STAFF REPORT

Subject: Bock Land Capability Challenge; 1105 Tiller Drive, Washoe County, NV; APN 130-211-11, TRPA File number LCAP2021-0257

Staff Recommendation:

Staff recommends the TRPA Hearings Officer approve this land capability challenge which would reduce land capability of Class 4 and increase Class 6, as well as change Class 1B to Class 6 due to lack of seasonal high water table for the lower portion of the property. This change is itemized on the table on Page 3 and depicted on a map included in Attachment C.

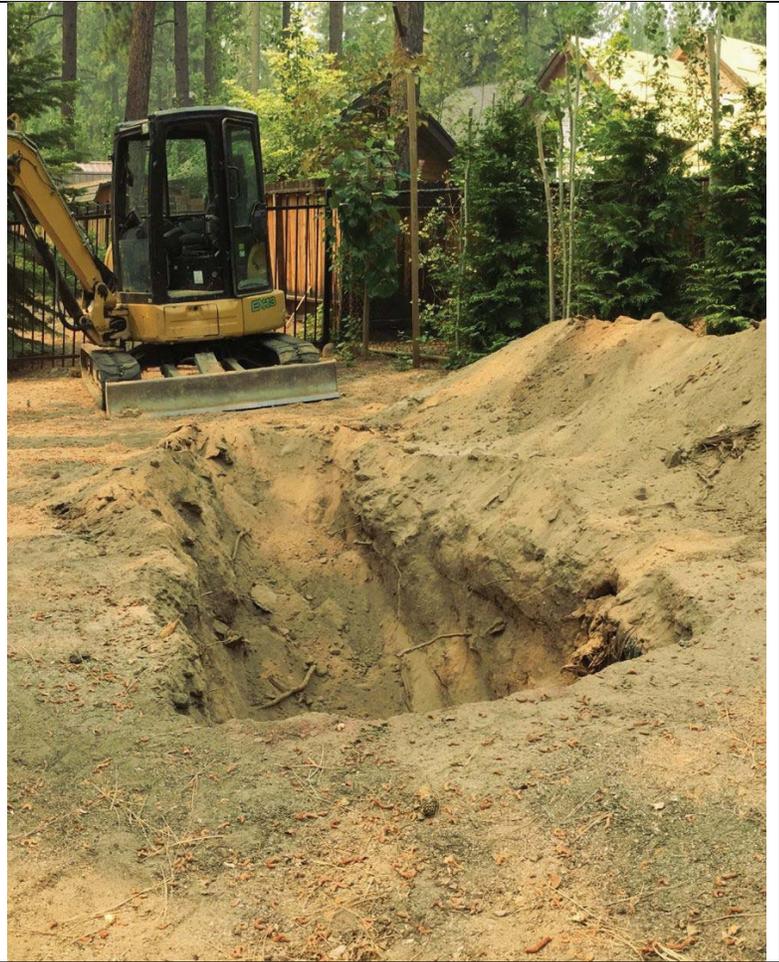
Photo 3 – Soil profile for north portion of property (aka lake terrace landform). Uppermost layers (16 inches thick) consist of dark brown loamy coarse sand. The subsoil, from 16 to 32 inches below the surface, is also loamy coarse sand, that shows little in-situ soil formation. The substratum below 32 inches (parent material) is gravelly sand. This soil is similar to Gefo and Elmira series in the 1974 soil survey; however, it shows less in-situ soil development. As per Land-Capability Classification of the Lake Tahoe Basin, California-Nevada, A Guide for Planning (Rbt. Bailey, 1974), this unnamed soil (XXX) qualifies as Class 6 (for 0 to 16% slopes).

Photo 4 – View southwest toward Pit #3, situated on lake terrace (same topographic setting as existing residence). This terrace is approximately 12 feet higher than the alluvial terrace that comprises most of the backyard. Site-specific soil conditions, and soil profiles were described by Davis2 Consulting Earth Scientists in August, 2021.

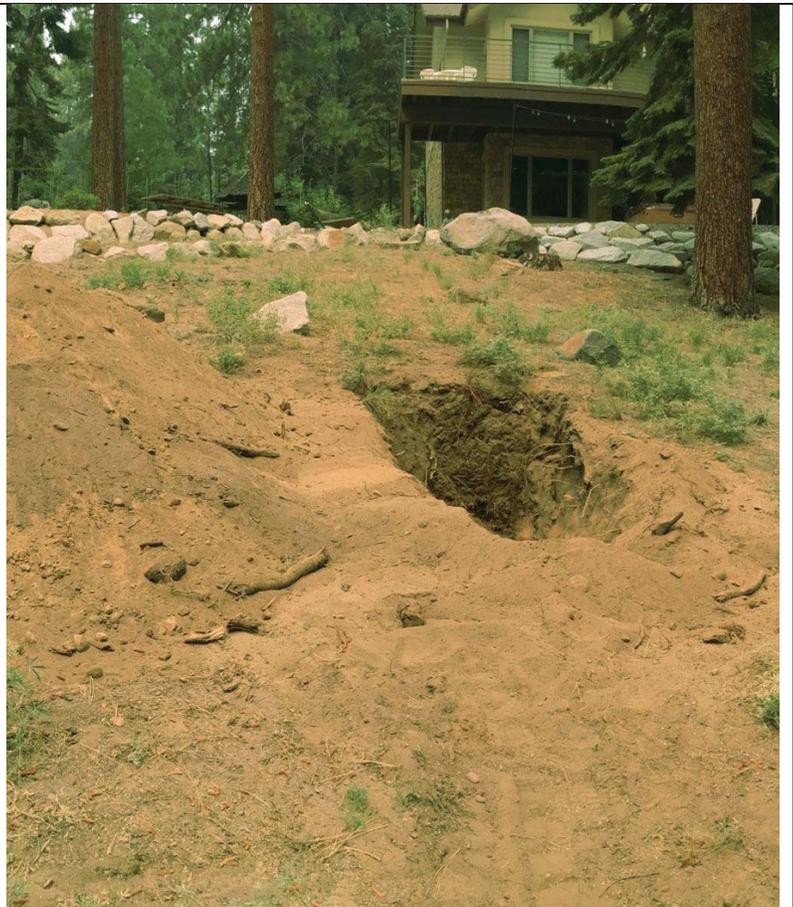
Photo 5 – Soil profile for escarpment below the lake terrace and above the alluvial terrace landform. The uppermost layers (19 inches thick) consists of dark brown gravelly loamy coarse sand. The subsoil, from 19 to 42 inches below the surface, is a sandy loam, that shows a slightly increase of illuviated iron (slightly redder tones), but not appreciable amounts of clay. The substratum below 42 inches (parent material) is a stony-gravelly sand. This soil is similar to Gefo and Elmira series in the 1974 soil survey; however, it has andesitic parent material and the substratum is more stony. As per Land-Capability Classification of the Lake Tahoe Basin, California-Nevada, A Guide for Planning (Rbt. Bailey, 1974), this unnamed soil (XXX) qualifies as Class 4 (for 16 to 30% slopes).

Photo 6 – View north at the transitional slope (aka natural escarpment) between upper lake terrace (older) and the alluvial terrace (opposite direction of photo). This soil at Pit #2 is deep and lacks any restricting layers, such as a fragipan or silica-cemented layer. Furthermore, no indication of seasonal groundwater was observed, such as redoximorphic features (iron staining, depleted matrix, pore linings). The slope of the escarpment ranges from 16 to 28%.

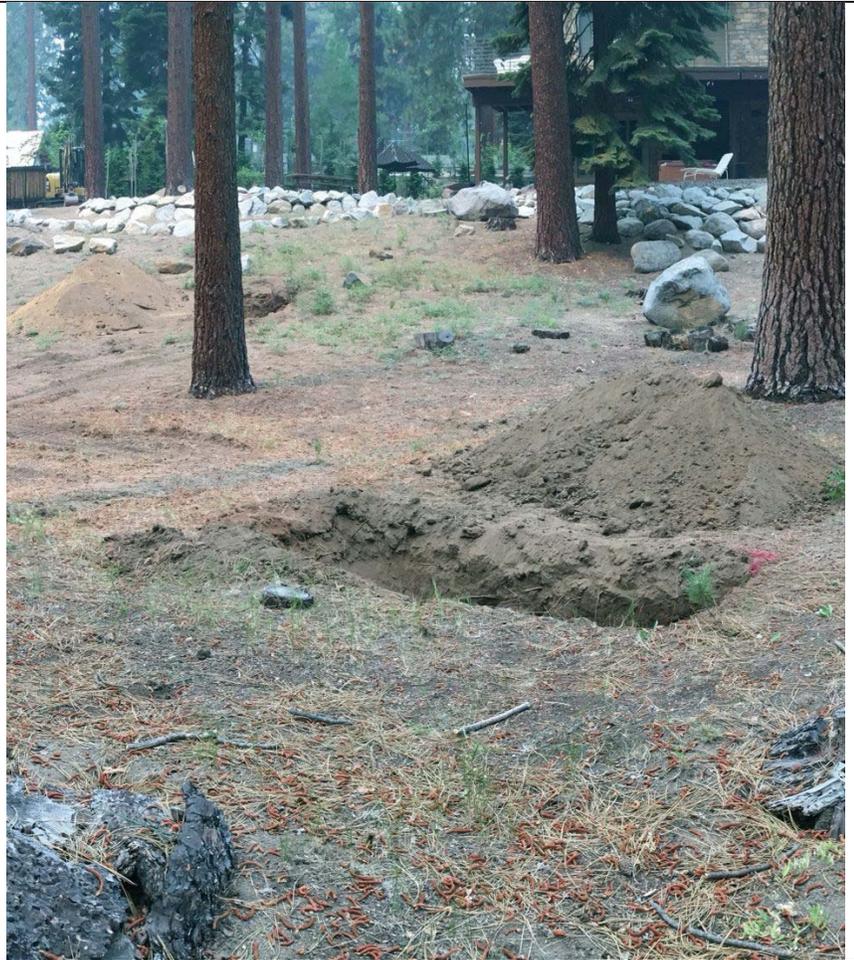
Photo 7 – Soil profile for the lower terrace (south and lowest part of parcel). The uppermost layers (16 inches thick) consists of dark brown sandy loam. The subsoil, from 16 to 30 inches below the surface, is a loamy coarse sand, that shows a slightly increase of illuviated iron (redder hue), but not appreciable amounts of clay. The substratum below 30 inches (parent material) is also loamy coarse sand. This soil is similar to Gefo and Elmira series in the 1974 soil survey; however, it has andesitic parent material. As per Land-Capability Classification of the Lake Tahoe Basin, California-Nevada, A Guide for Planning (Rbt. Bailey, 1974), this unnamed soil (XXX) qualifies as Class 6 (for 0 to 16% slopes).

Photo 8 – View northwest toward Pit #1, situated on the alluvial terrace landform. This terrace slopes very gently to the south (2 to 16%). Like the soils on the lake terrace and escarpment, the alluvial terrace soils are deep and lack any restricting layers, such as a fragipan or silica-cemented layer. Furthermore, no indication of seasonal groundwater was observed, such as redoximorphic features (iron staining, depleted matrix, pore linings). The lack of such features is essential to the conclusion that this terrace is not, nor historically SEZ. That is, the alluvial sediments were natural flood sediments, but such area did not have a seasonal high water table.

Figure 1- Flood plain in relation to subject parcel.

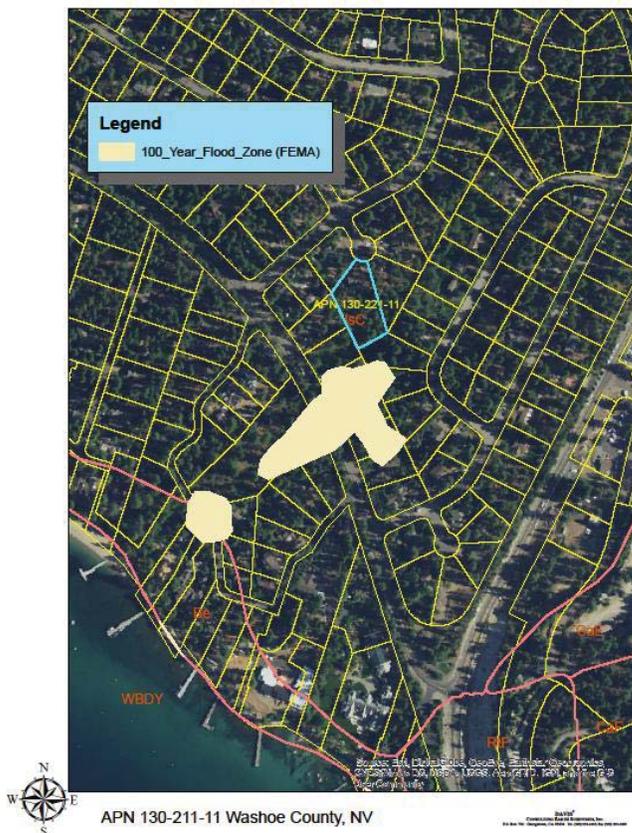
Soils are found to be very deep, Excessively drained, members of Hydrologic Soil Group A. Three excavations examined were all similar with respect to soil depth and texture with an intervening steeper slope that separates two terrace treads. Soils on the lower tread (Stop 1) can be characterized having a mixed topsoil consisting of dark brown loamy sand immediately above a crotovina-laced transitional (AB horizon) top soil approximately 16 inches thick, over dark yellowish brown cambic (structural Bw) loamy coarse sand subsoil to 64 inches depth. Mature Jeffrey pine occupy this surface and roots explore the soil profile to more than 60 inches. Hydrophytic vegetation is devoid of the area as well as any wetness indicators (redoximorphic features) that might be associated with wetness. A TRPA verification showing this area mapped as 1b (flood plain) is not substantiated by flood plain overlays (Figure 1).

There is no SEZ or Class 1b area on the parcel and the mapped flood plain is well offsite to the south (Figure 1).
